31/6-00H 10405 Fawcett Street¹⁴
(Kensington Historic District)

SUBJECT: Historic Area Work Permit

KAHIN RESIDENCE NEW DECK

HISTORIC PRESERVATION COMMISSION STAFF REPORT

A-1

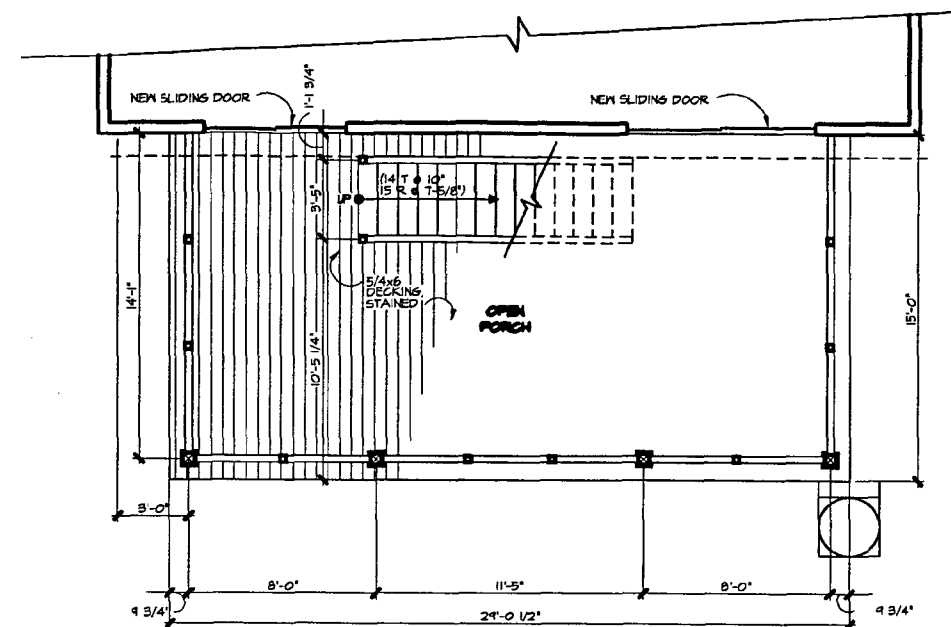
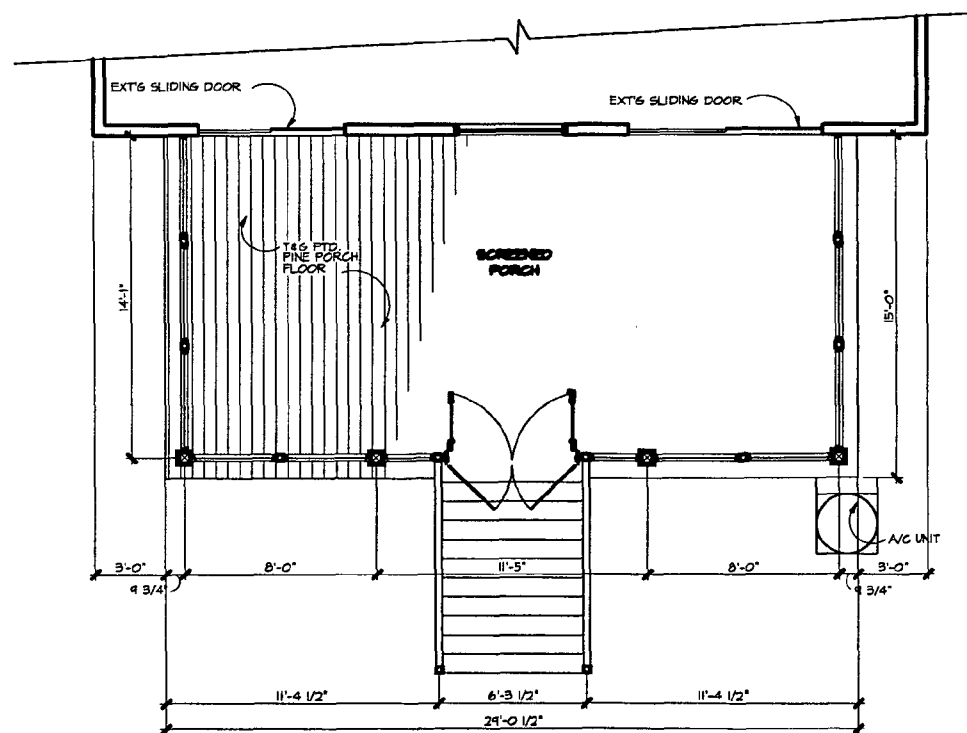
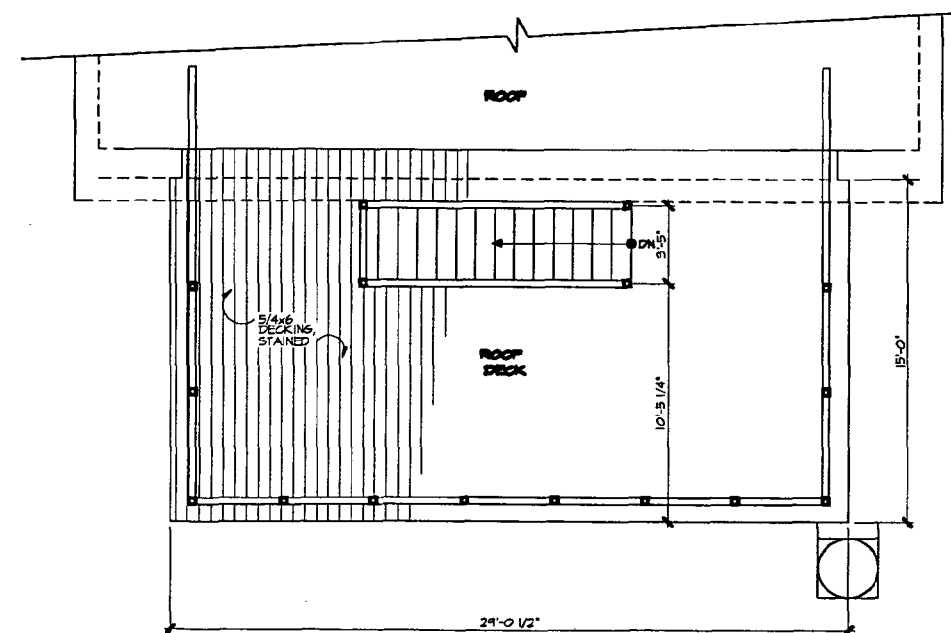
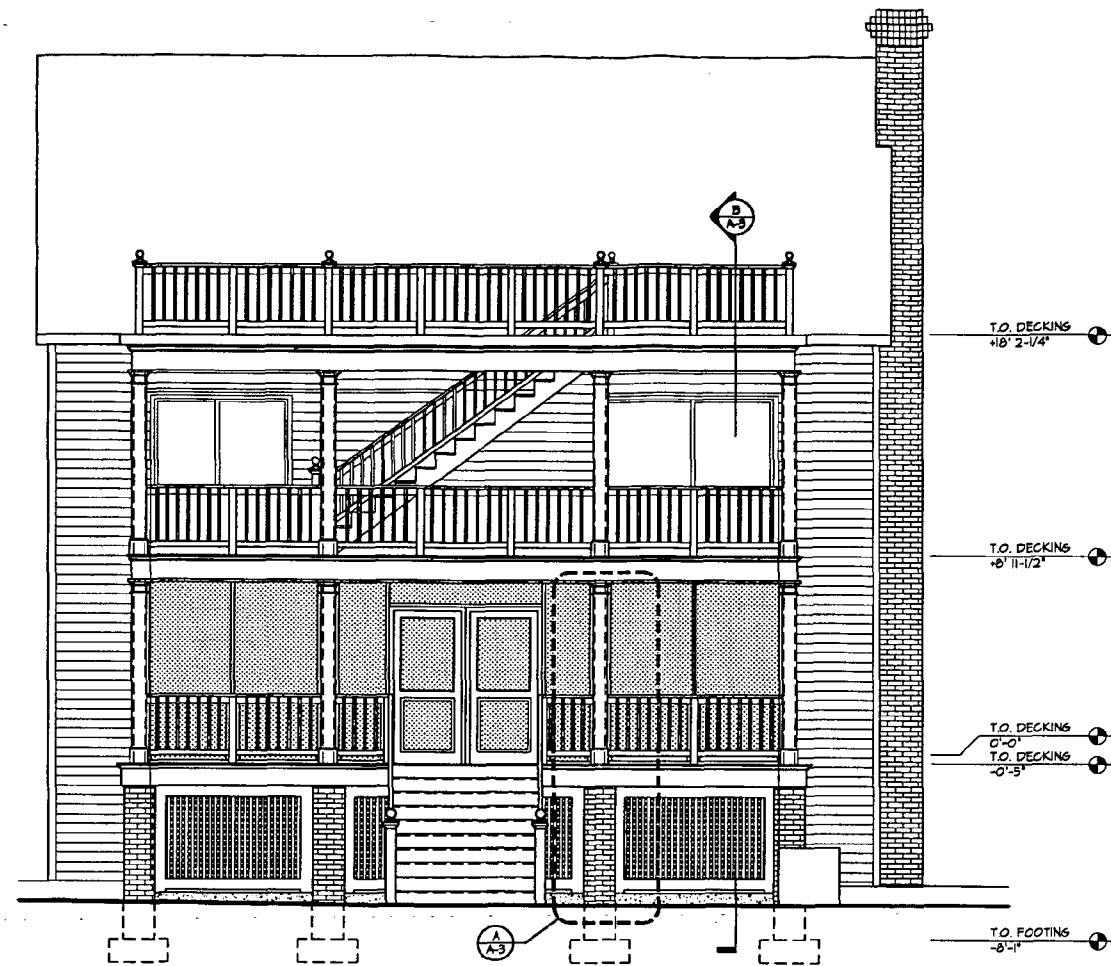
There is an existing full-width deck located at the rear of house. The proposal is to convert this deck into a 29'x15' screened porch. An open porch with rooftop deck will be installed on top of the proposed screened porch. The proposed design will be three stories in total height.

Date: 07-08-99 Scale: 1"=30' Dwn: B.D.
Plat Book: NO TITLE REPORT FURNISHED
Plat No.:
Work Order: 99-3204
Address: 10405 FAWCETT STREET
District: 13
Jurisdiction: MONTGOMERY COUNTY, MD

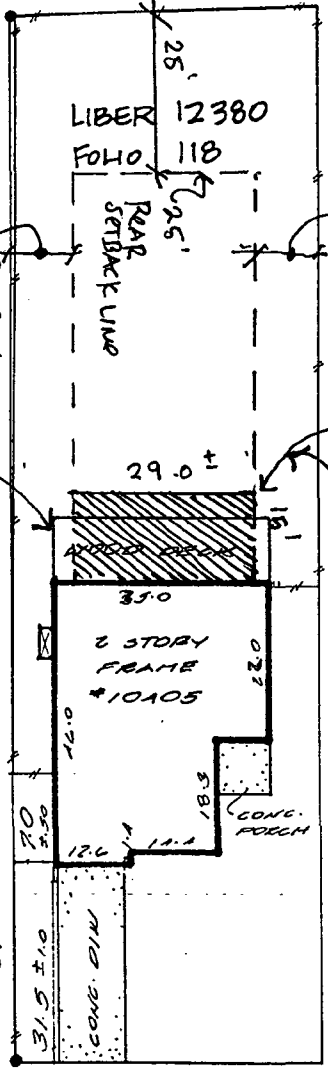
The existing rear deck on this non-contributing resource measures 10' in depth and 35' wide. The footprint of the new deck will measure 15' in depth and 29' wide. The percentage of lot coverage will be increased from 21% to 22% (Circle 7).

The new deck also meets the Montgomery County and Town of Kensington set-back requirements (Circle 8).
